Recall Service Bulletin

RSB20-560-001

APPLIES TO: This Recall Service Bulletin applies to Spartan Fire, LLC Model Year 2012-2016 Gladiator and Metro Star cab-chassis built between August 8, 2012, and October 11, 2016. Vehicles affected are limited only to cab-chassis equipped with Spartan Advanced Protection System that have had a replacement instrument panel S-2708-001 installed.

CONDITION: Advanced Protection System may not be operable after replacement of original instrument panel with kit S-2708-001.

FIG 3-1

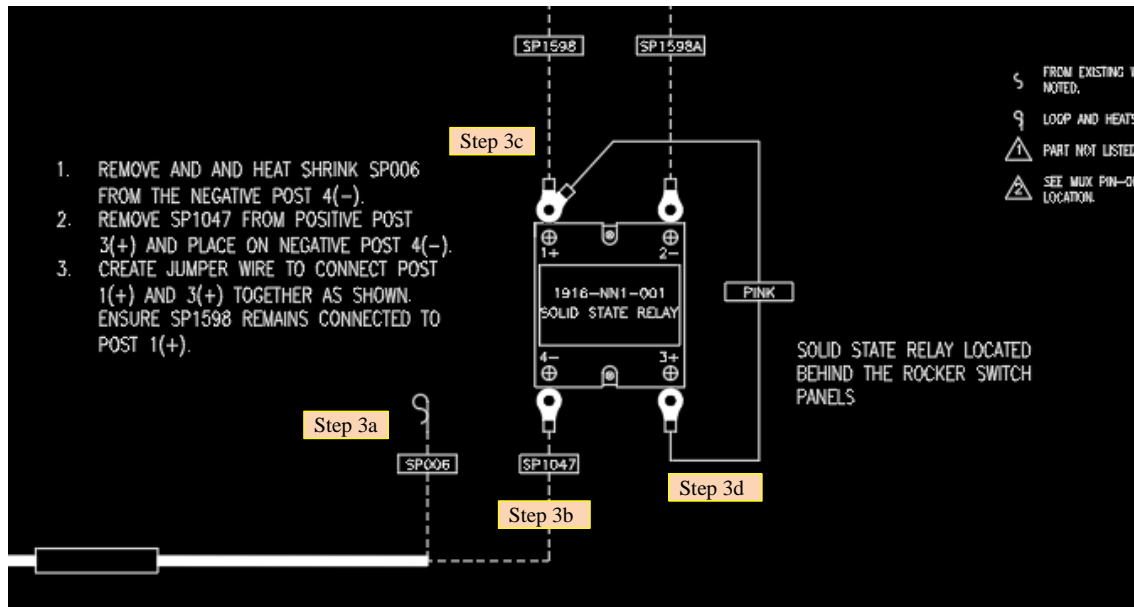
3. Use the provided diagram 0221-GG9-3471 to rework the circuits connected to the solid-state relay, as shown in FIG 3-1:

- Remove SP006 from Post 4(-) and protect the end of the wire.
- Remove SP1047 from the Post 3(+) and place on Post 4(-)
- Connect the pink wire created in step 1 to Post 1(+), leaving current wire SP1598 connected.
- Connect the other end of the pink wire to post 3(+).
